Technical Service Bulletin

FRONT DOOR INTERFERES REAR DOOR GARNISH (MAZDA3 5-DOOR HATCHBACK)

Bulletin No.: 09-014/22

Last Issued: 09/12/2022

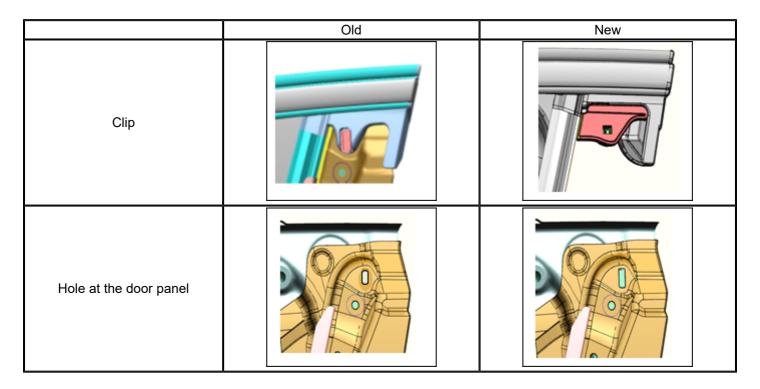
Some vehicles may exhibit that the glass run channel of the front door interferes with the rear door garnish.

Since the front door glass run channel is not fixed to the door strongly enough for the following situations, cycles of door operation may result in interference and lead to damage on the seal rubber at the rear door.

- When the front door glass is closed, the glass run channel may be forced to move to the B pillar side.
- In very hot climates, the glass run channel may expand to the B pillar side.

- Phase 1
 - Adhesive has been added between the front door glass run channel and the door panel.
- Phase 2
 - The shape of the front door glass run channel has been changed so as not to make contact with the rear garnish.
 - The shape of the clip at the rear side of the front door glass run channel has been changed for stronger fixing and the hole at the door panel has been changed accordingly.
